**BEFORE
THE OHIO POWER SITING BOARD**

In the Matter of the Letter of Notification)
Nottingham Solar, LLC for the 138 kV Gen-)
Tie Transmission Line Project, Athens) Case No. No 22-1030-EL-BGA
Township, Harrison County, Ohio)

**NOTTINGHAM SOLAR LLC GEN-TIE TRANSMISSION PROJECT RESPONSE
TO OPSB STAFF SECOND DATA REQUEST DATED NOVEMBER 28, 2022**

Figure 1

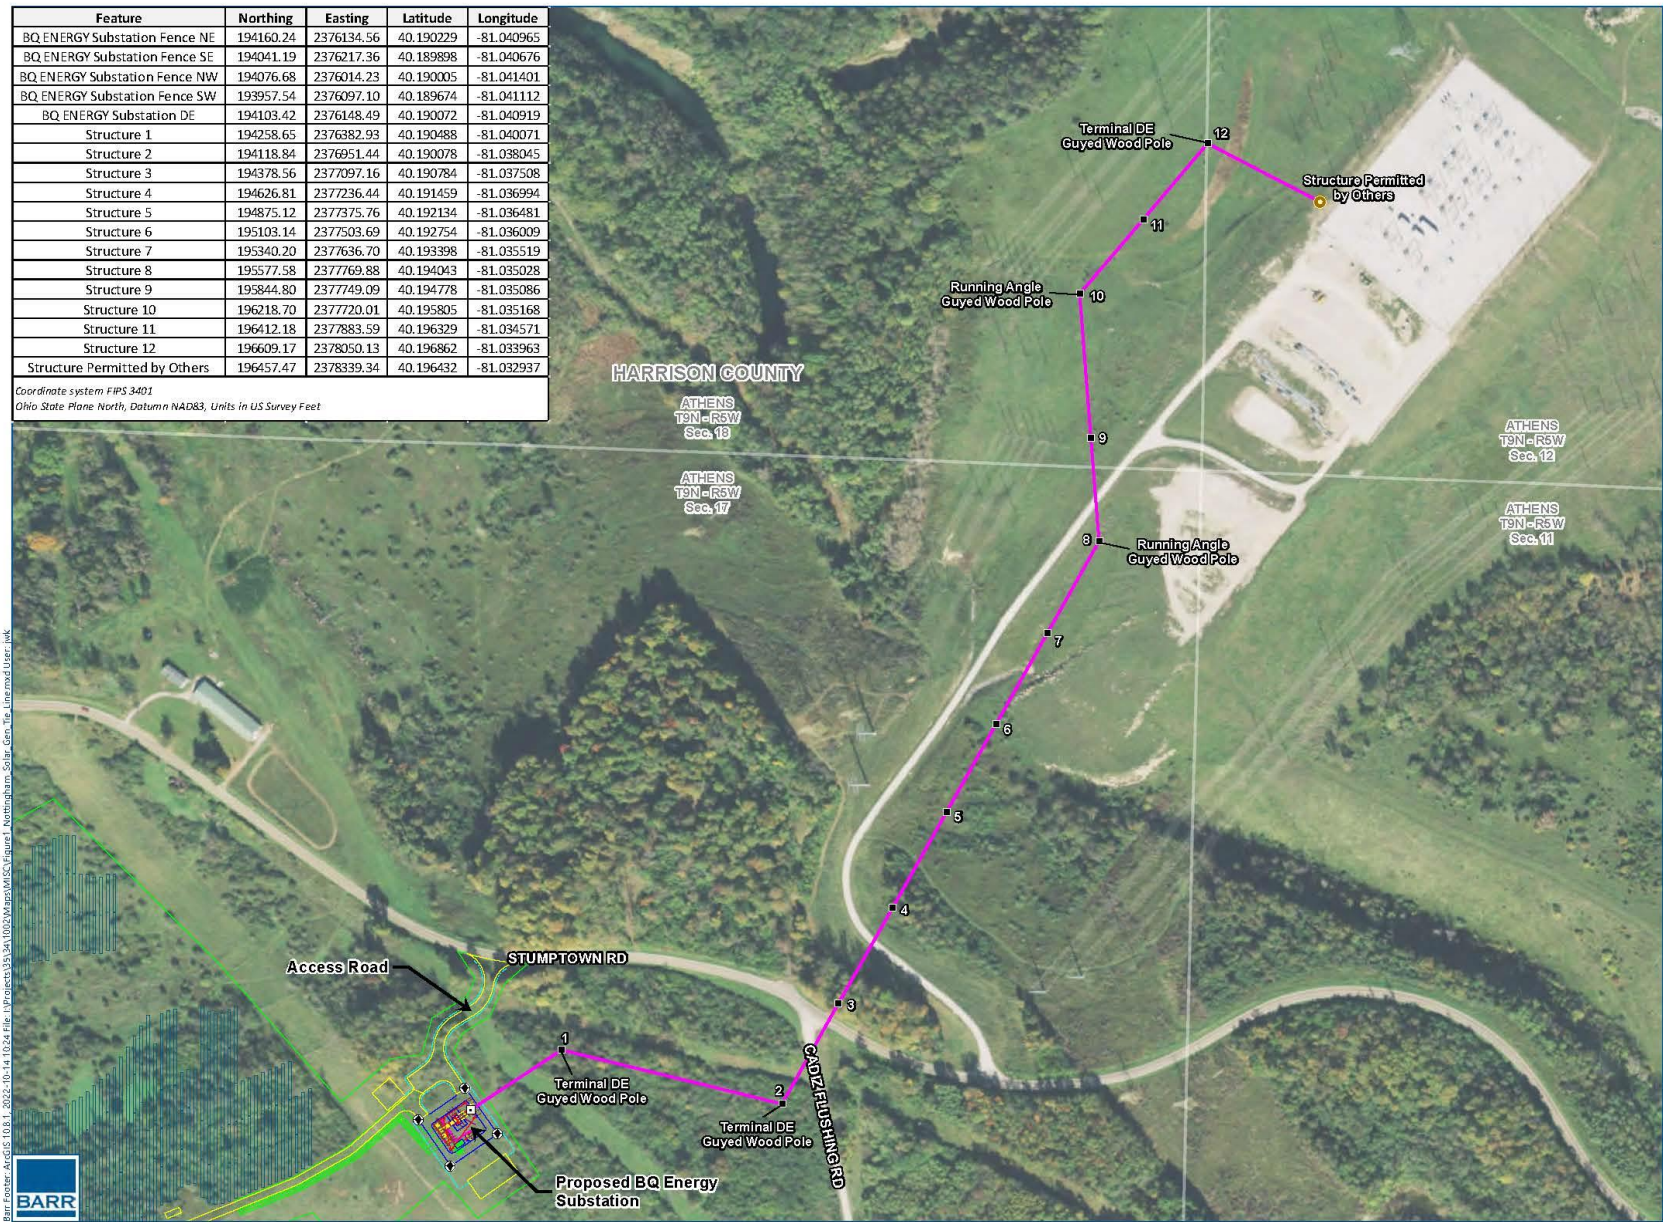
- 4) Please provide Staff with a figure/diagram of pole locations and pole foundations.

RESPONSE: Please see Figure 1 below. The coordinates for the pole locations are provided in the table. All poles will be direct embedded wood poles; therefore, there are no foundations.
